Re: Proposed Nelson Meadow Detention Area

With regard to the proposed Nelson Meadow subdivision, I believe that the petitioner has failed to show that a safe and reasonable storm water detention area can be constructed with the proposed lot configuration. (I am not questioning the capacity or outflow rate of the detention area.) My remarks apply to the engineering drawings dated September 26, 2005, which were reviewed at the December 12 Plan Commission hearing.

Figure 1

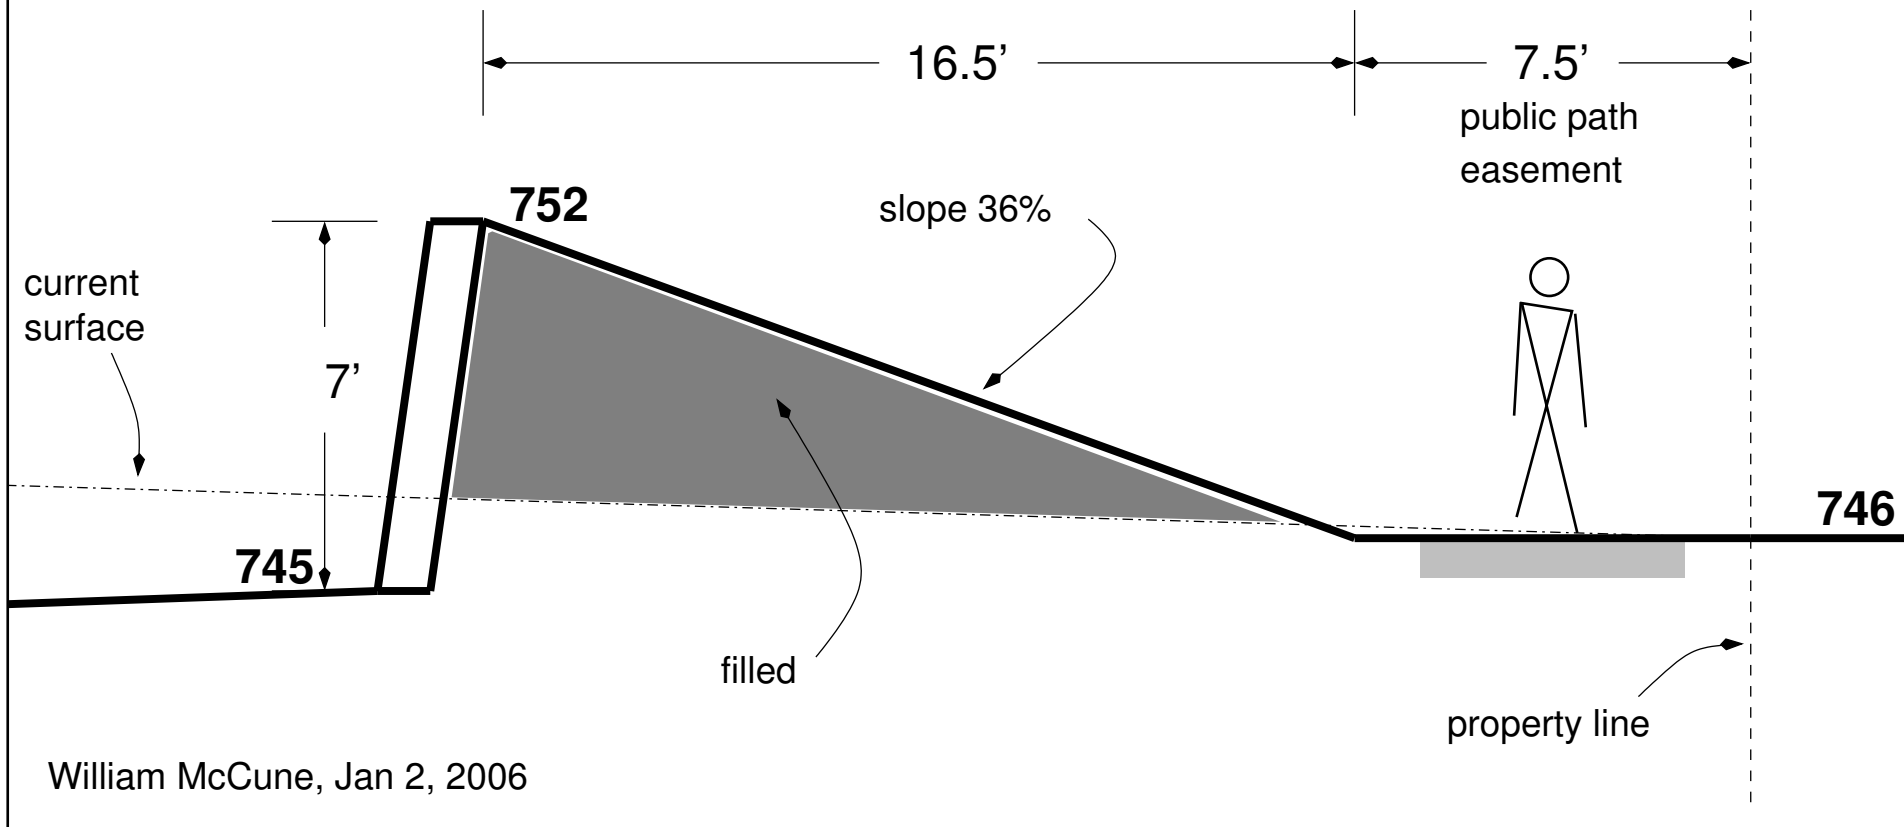
1. **Unsafe Slope Beside Walking Path.** Figure 1 shows a cross section looking east toward Carpenter Street along the proposed public walking path easement. The section is near the east end of the proposed retaining wall. The slope would be at least 36%. The generally recommended maximum slope for safe maintenance is 25%.

Figure 2

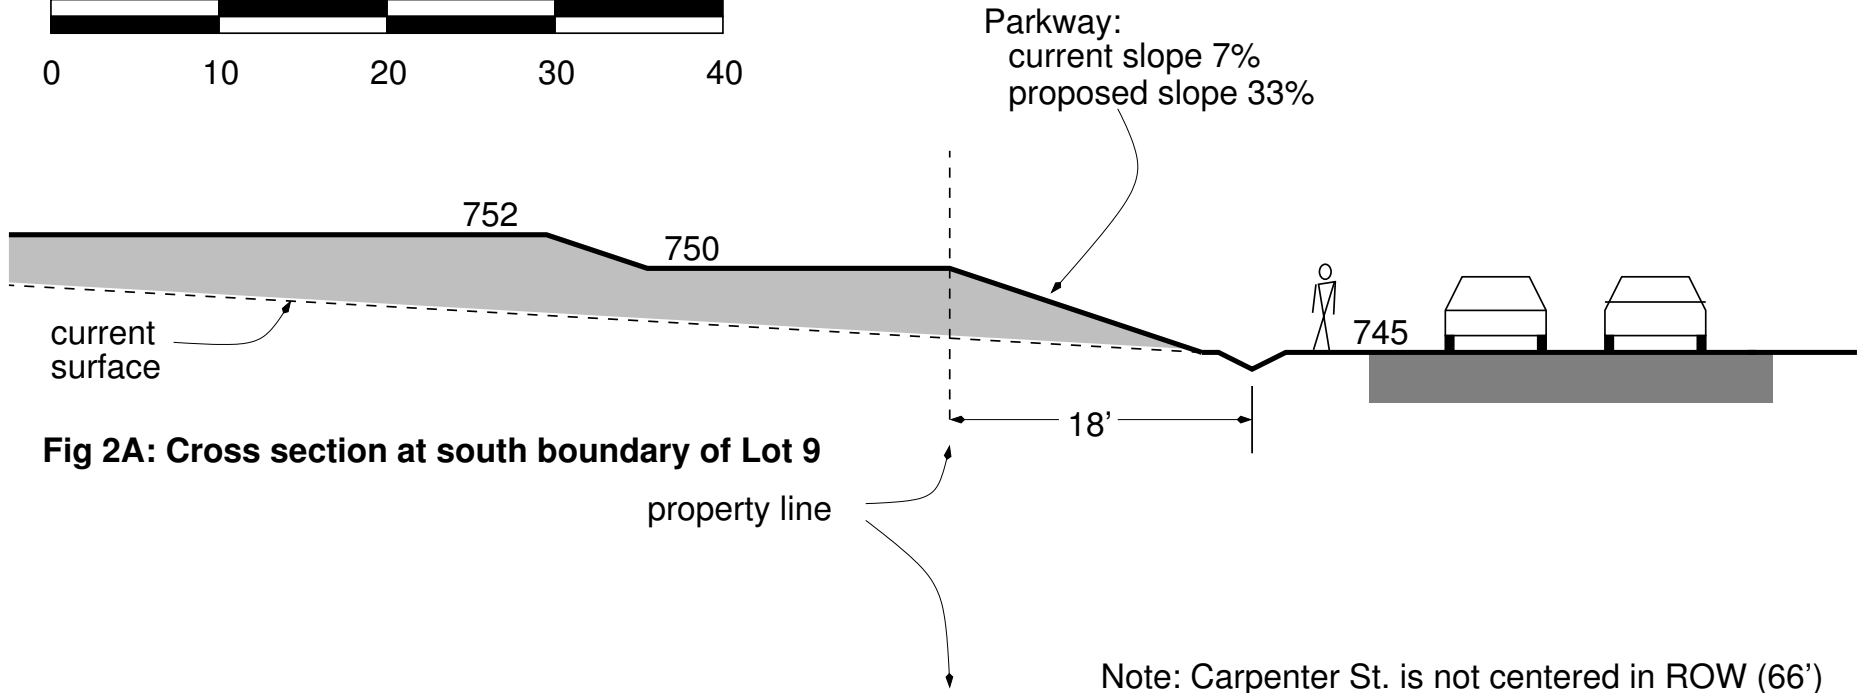
2. **Encroachment of Grading upon Village Parkway.** Figure 2A shows a cross section at the south boundary of Lot 9, looking north along Carpenter Street. The proposed grading would require about four feet of fill on part of the village parkway, would extend nearly to Carpenter Street, and would create an unsafe slope of 33% on village parkway.

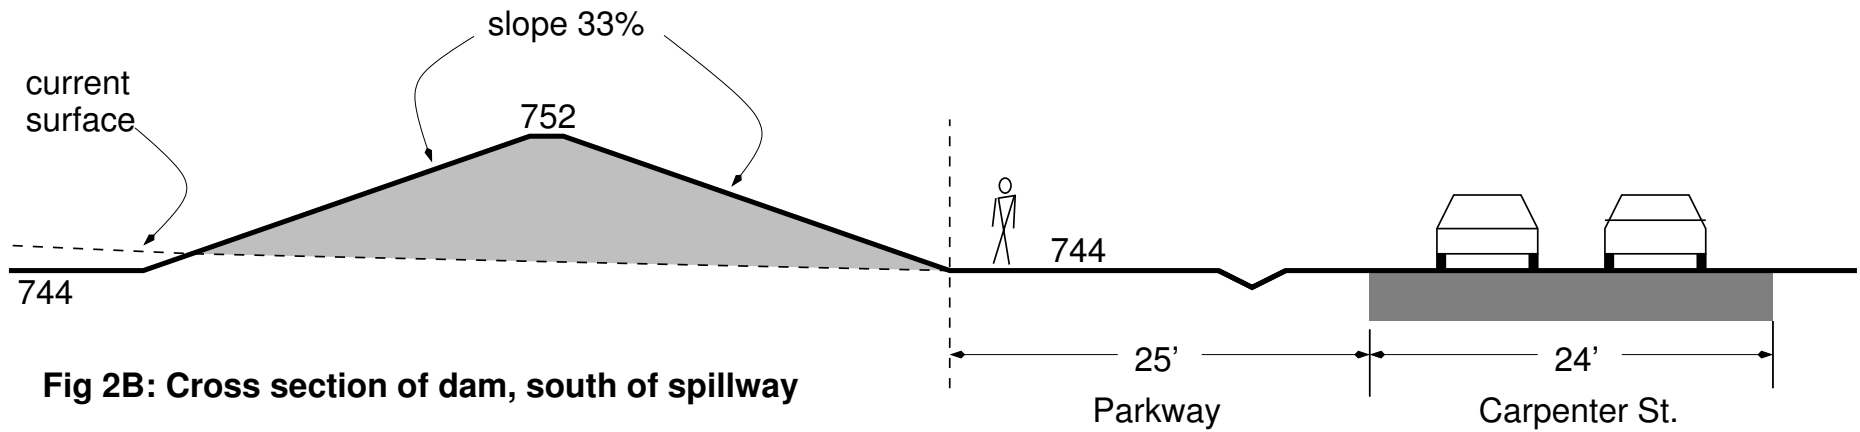
3. **Unsafe (and Unsightly) Dam Along Carpenter Street.** Figure 2B shows a cross section of the proposed dam just south of the spillway, looking north along Carpenter Street. Note that the bottom of the proposed detention area is at the same elevation as Carpenter Street, and the dam is eight feet high. The slope is unsafe at 33%. If not for the traffic on Carpenter Street, this would be a nice sledding hill for neighborhood kids.

**Figure 3**

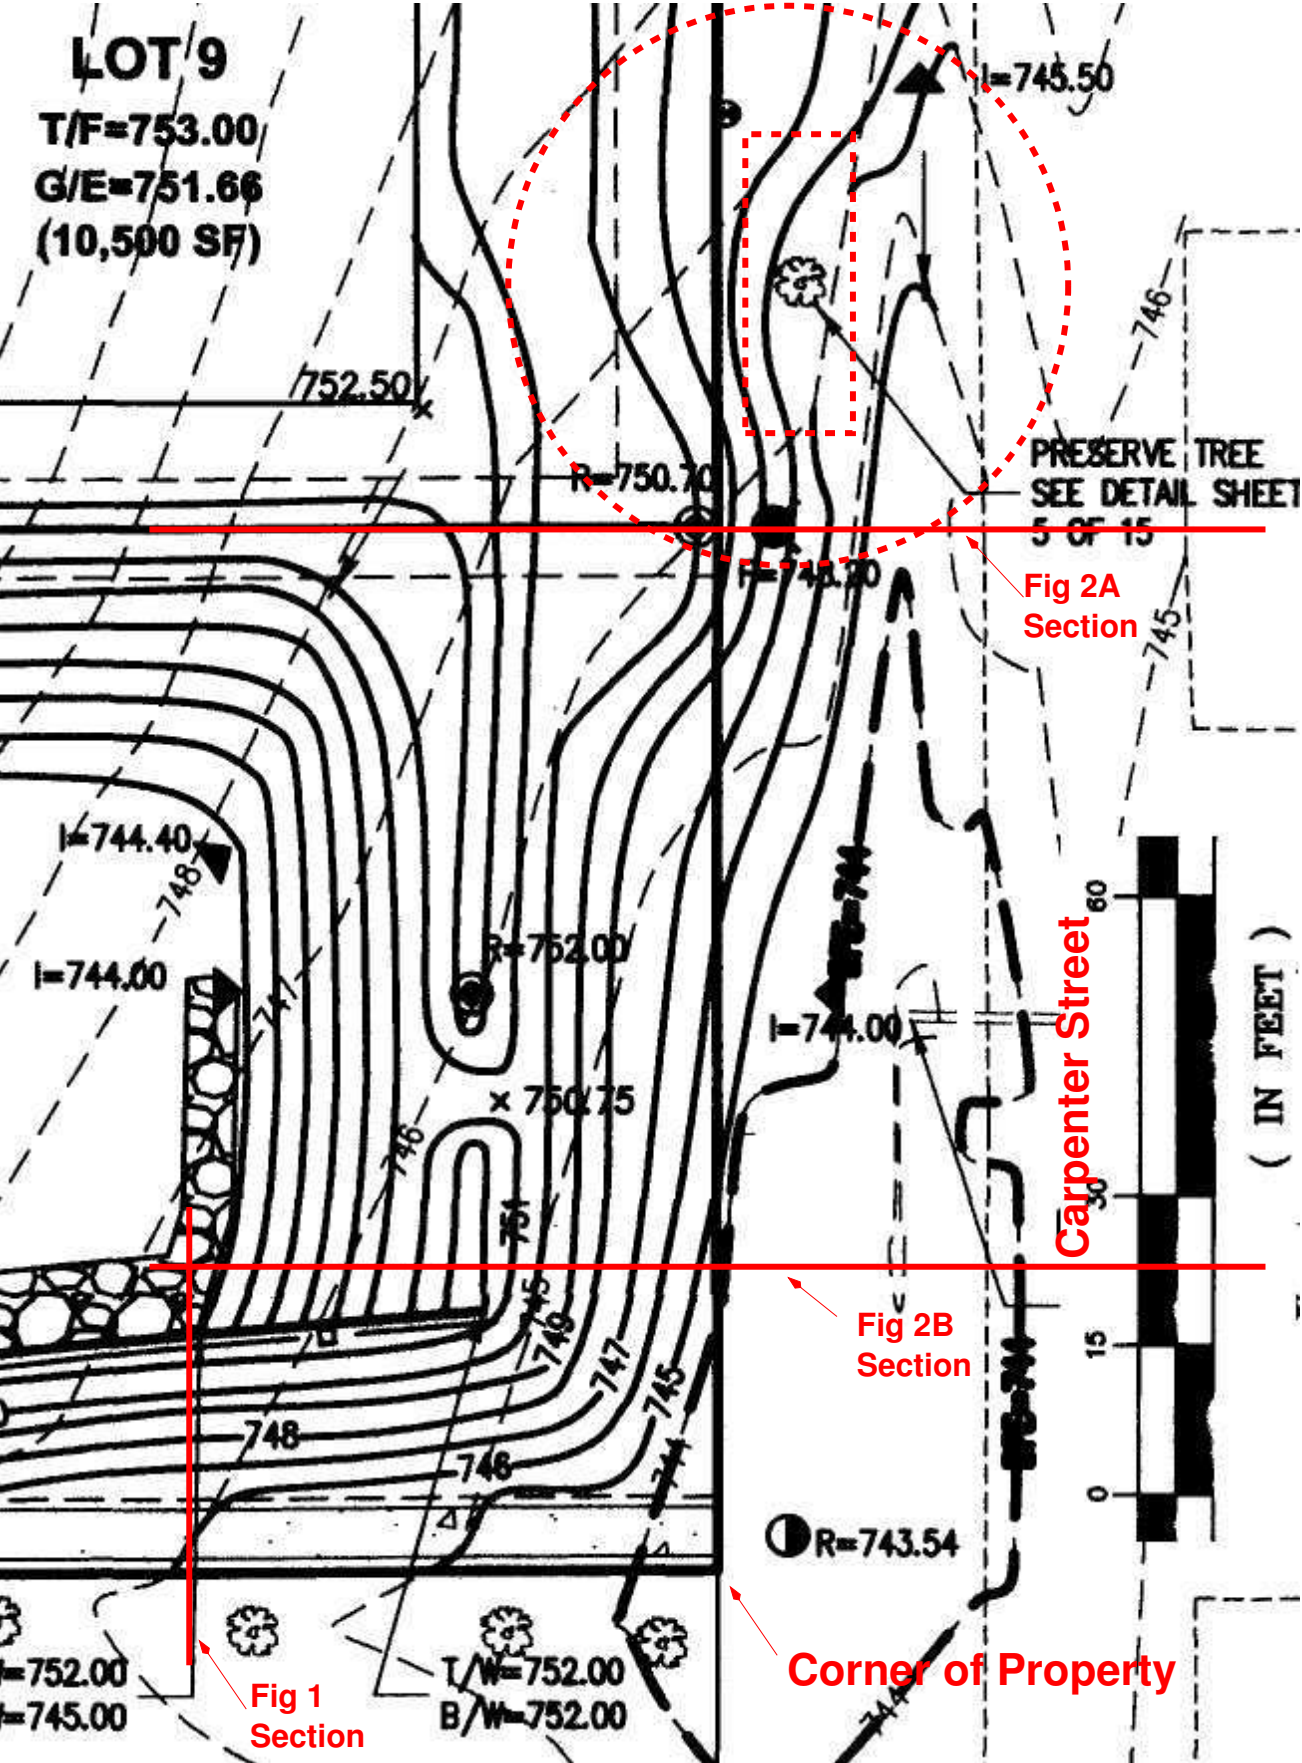
4. **Inconsistency of Plan with "Downers Grove Tree Protection Requirements".** See the "Preserve Tree" notation (top right) in Figure 3. This refers to a 30 inch silver maple on village parkway. The dotted circle (radius 30 feet) is the industry-standard Critical Root Zone. The smaller dotted rectangle (10 by 30 feet) applies to village parkway trees greater than 24 inches: it is the minimum area that must be fenced and undisturbed. The grading plan shows substantial regrading within the fenced area.
